Subject: Specification of service life limitations for the brake hoses of the hydraulic wheel brake

Applicability: **ASH 25;** all models¹; Type-Certificate EASA.A.213; all serial numbers
ASH 26 E; Type-Certificate LBA 883; all serial numbers

Classification: Major Change

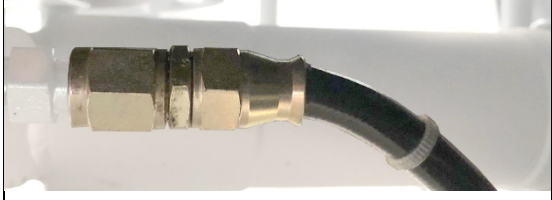
<p>Brake hoses of the old type made from rubber material, identifiable by the shown fitting shape and the textile fabric wrapping of the hose.</p>
	<p>Brake hoses of the new type, identifiable by the shown fitting shape.</p>

Brake hoses of the **old type**: This brake hose has to be exchanged in regular intervals of 6 years. If the brake hose is in good condition, it is not necessary to exchange the hose. Operation on condition requires the inspection of the hose for proper condition at least every 100 h.

Brake hoses of the **new type**: This brake hose has no service life limitation (on condition).
